**Car Stereo
Service Bulletin**

Model: CDX-U606; XES-P1/X1

No. 314

Subject: No Audio After AMS Or Disc Change

[SERVO BOARD]

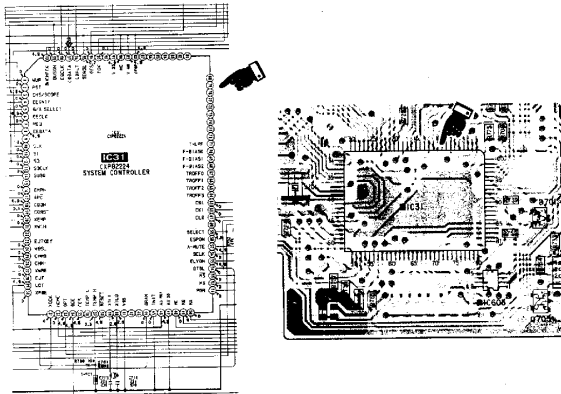
If the CDX-U606 is used in a system which also includes the XES-P1 and XES-X1 the audio may cut out after AMS'ing or after changing discs.

If this symptom occurs in the above mentioned system configuration, replace CPU IC31 on the **CDX-U606 Servo board** with an improved version.

REF	DESCRIPTION	PART NUMBER
IC31	IC, CXP82224-013Q	8-752-853-08
